**Nebraska Public Power District**

NLS2003027

**Subject:** Response to NRC Generic Letter 96-06  
Cooper Nuclear Station, NRC Docket 50-298, DPR-46

### Response to NRC Request for Additional Information NRC Letter dated April 24, 1998

FIGURE 2

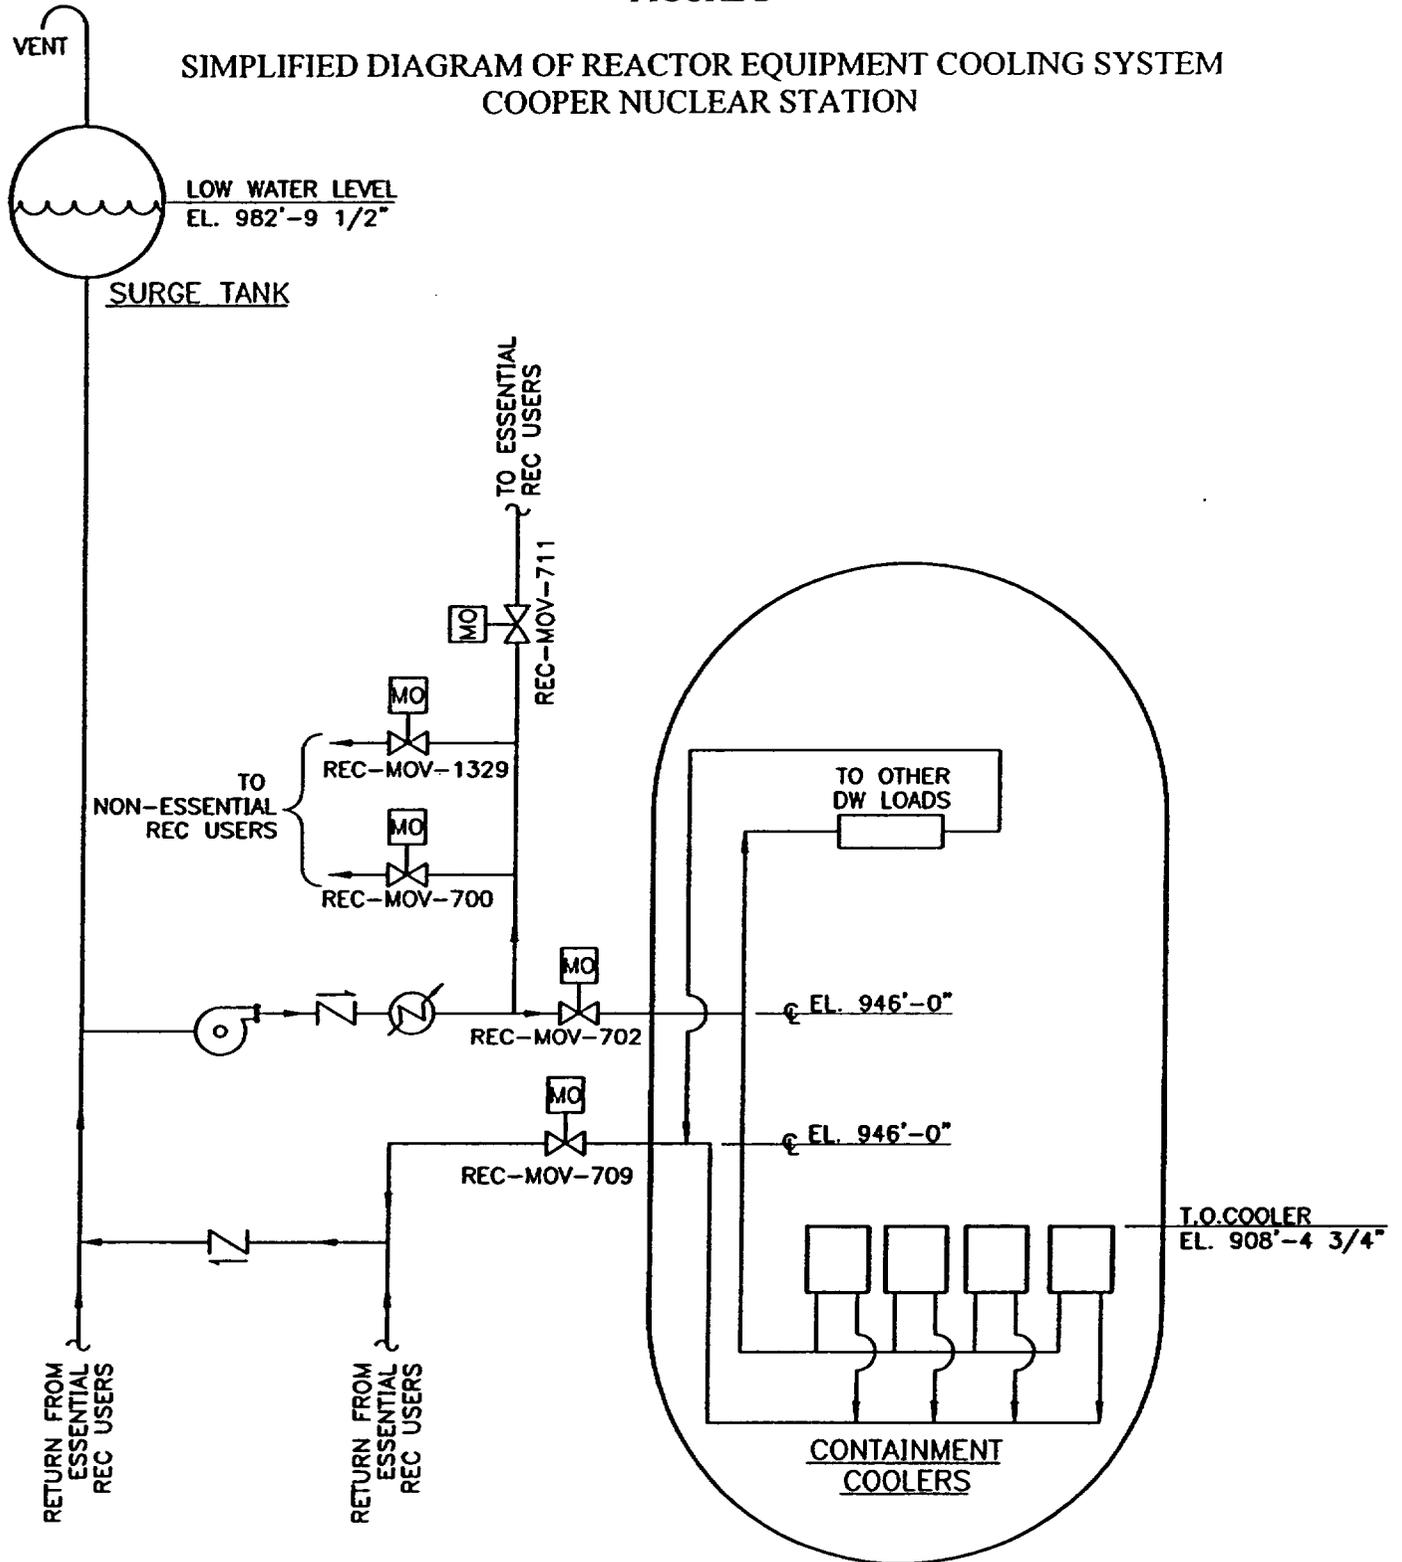
*Provide a simplified diagram of the system, showing major components, active components, relative elevations, length of piping runs, and the location of any orifices and flow restrictions.*

A simplified flow diagram of the REC System showing the major and active components is provided as Figure 1. A simplified diagram showing the elevations of the major components is provided as Figure 2. (The box in Figure 2 entitled "Other DW loads" represents loads that are located both above and below the coolers. For simplicity of the figure these elevations are not shown.) The lengths of piping runs are not shown in Figure 2 since CNS considers the lengths of piping runs in the REC System as having little or no impact on the applicable analyses.
